Economic and Social Council

186th session

Proposal for Supplement 5 to the original series of amendments to UN Regulation No. 149 (Road illumination devices)

Submitted by the Working Party on Lighting and Light-Signalling^{*,**}

“Figure A4-V

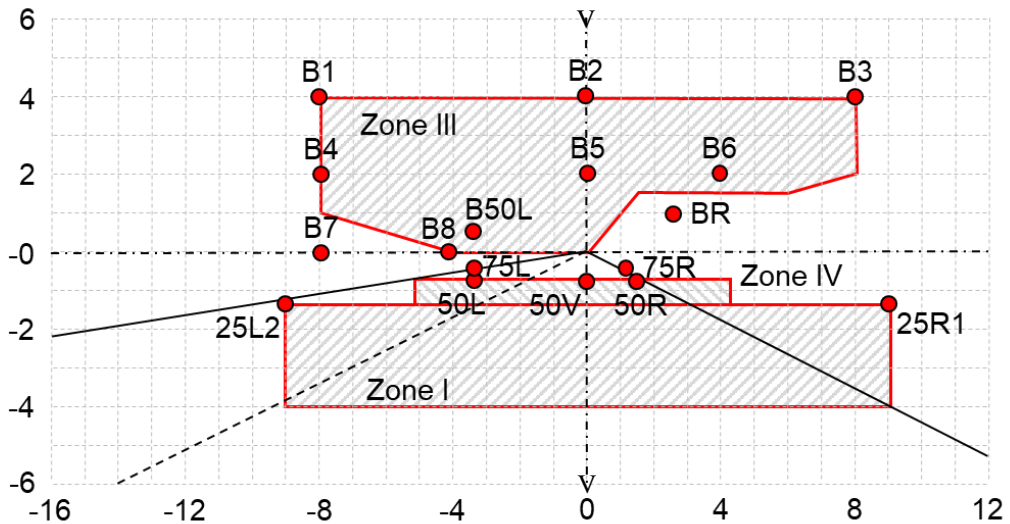
Figure A4-V, amend to read:

Passing-beam for right-hand traffic

The test point locations for left-hand traffic are mirrored about the VV line”

“Figure A4-VII

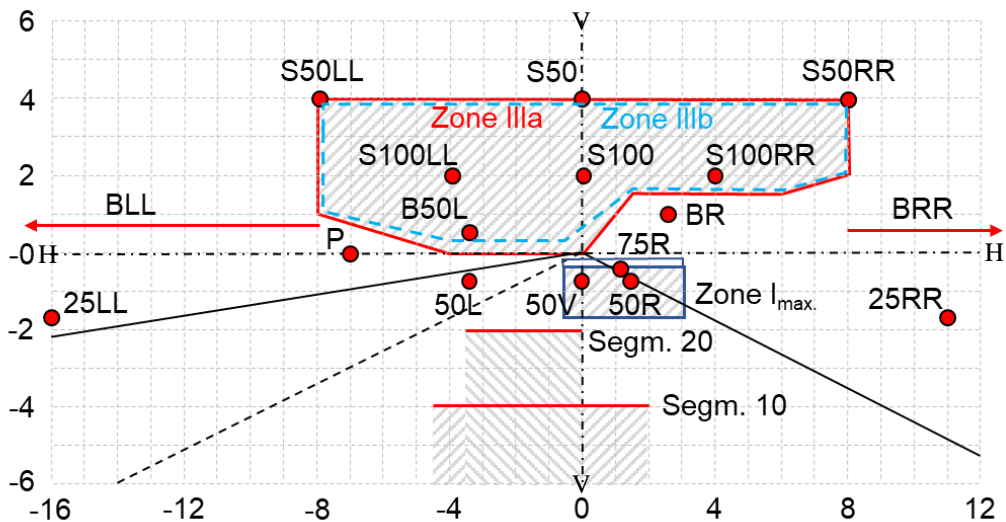
Figure A4-VII, amend to reads:

AFS Passing-beam for right-hand traffic*

* Note: The measurement procedure is prescribed in Annex 4

Angular positions of passing-beam photometric requirements are indicated for right-hand traffic and are expressed in degrees up (U) or down (D) from H-H respectively right (R) or left (L) from V-V.

The test point locations for left-hand traffic are mirrored about the V-V line
